TOWN OF NEWBURGH PLANNING BOARD TECHNICAL REVIEW COMMENTS

PROJECT NAME:IRON CHEF AMENDED SITE PLANPROJECT NO.:22-09PROJECT LOCATION:101 NORTH PLANK ROADSECTION 75, BLOCK 1, LOT 8REVIEW DATE:26 AUGUST 2022MEETING DATE:1 SEPTEMBER 2022PROJECT REPRESENTATIVE:BURNS ENGINEERING SERVICES, PC

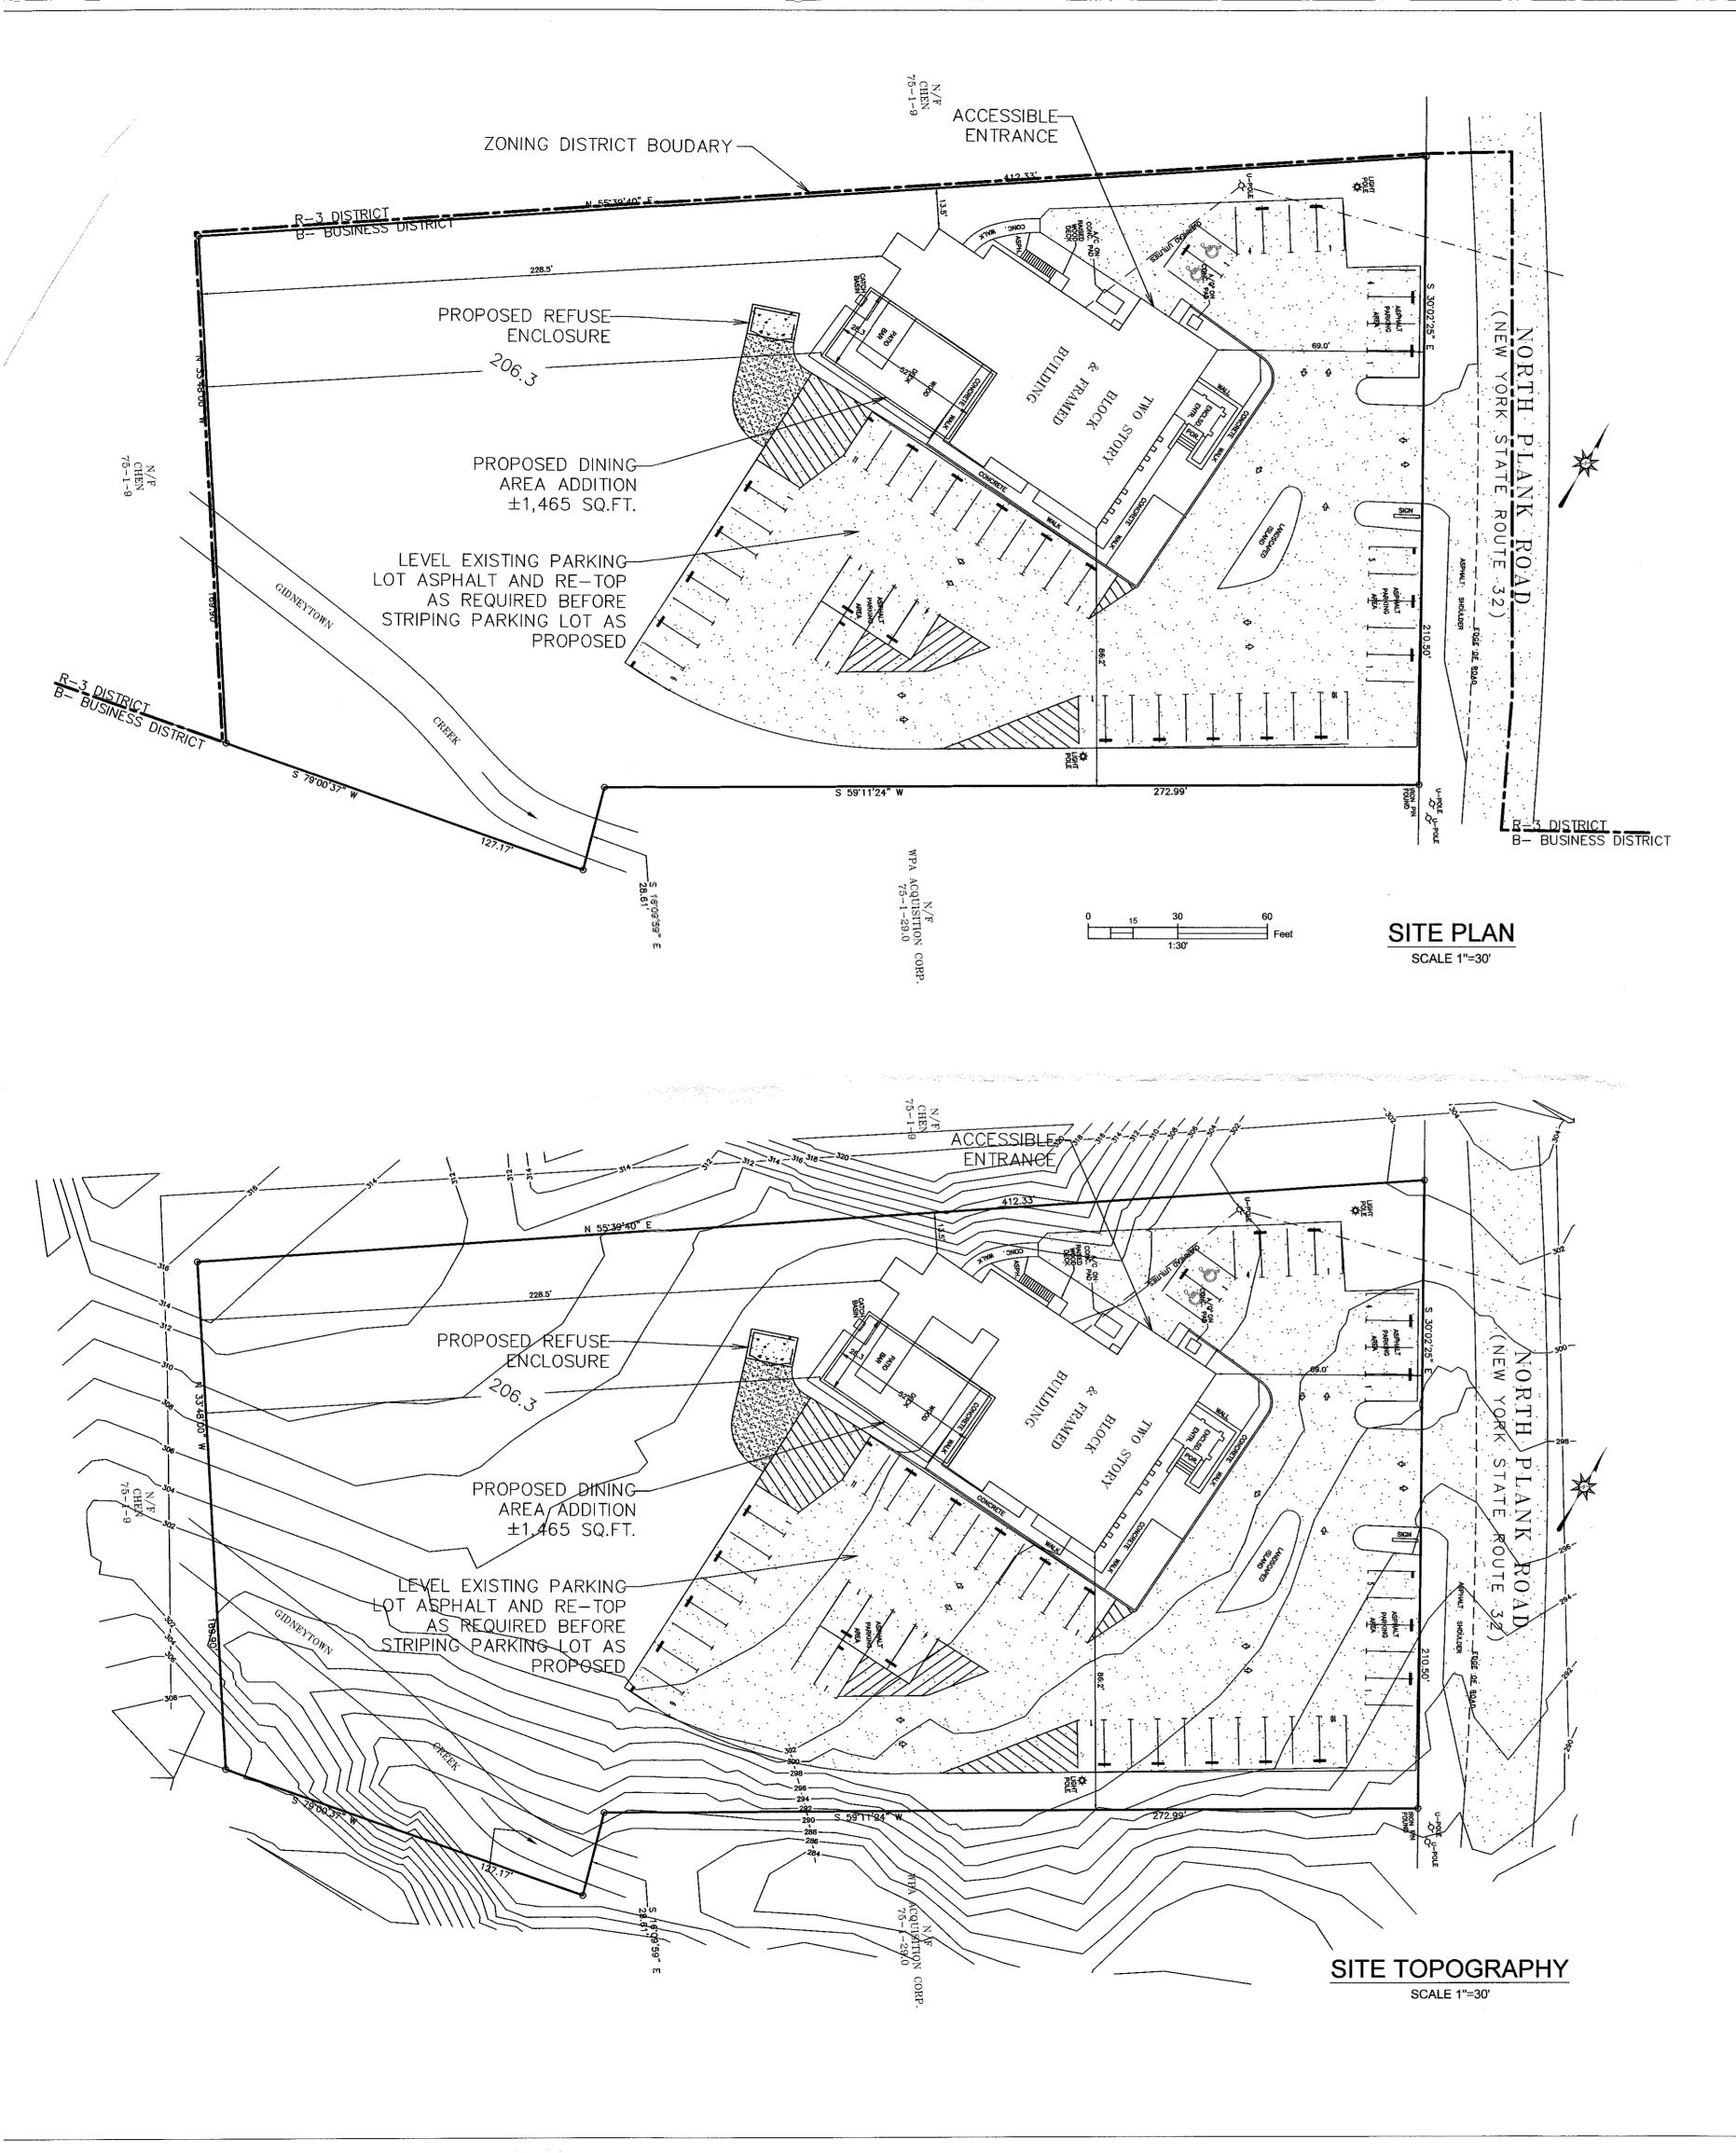
- 1. Adjouners Notices have been sent to surrounding property owners.
- 2. County Planning referral is required.
- 3. The applicants have identified an increase hydraulic loading from the site of 1,995 gallons. A City of Newburgh Flow Acceptance Letter for this increase loading is required.

- 4. The applicants have identified that a variance from the Zoning Board of Appeals has been received.
- 5. Details of the proposed refuse enclosure should be provided.

- 6. Specific paving details should be added to the plans. Currently a note states "level existing parking lot asphalt and repave as required be for striping parking lot as proposed." Parking lot paving details should be added.

- 7. Submission to NYS Department of Transportation should be provided. Applicants response letter identifies they have submitted to DOT. Response from DOT should be received.

- 8. Accessible parking detail should be added to plans including signage and universal blue painted symbols.
- 9. ZBA decision should be noted on the Bulk Table with date of ZBA variance.
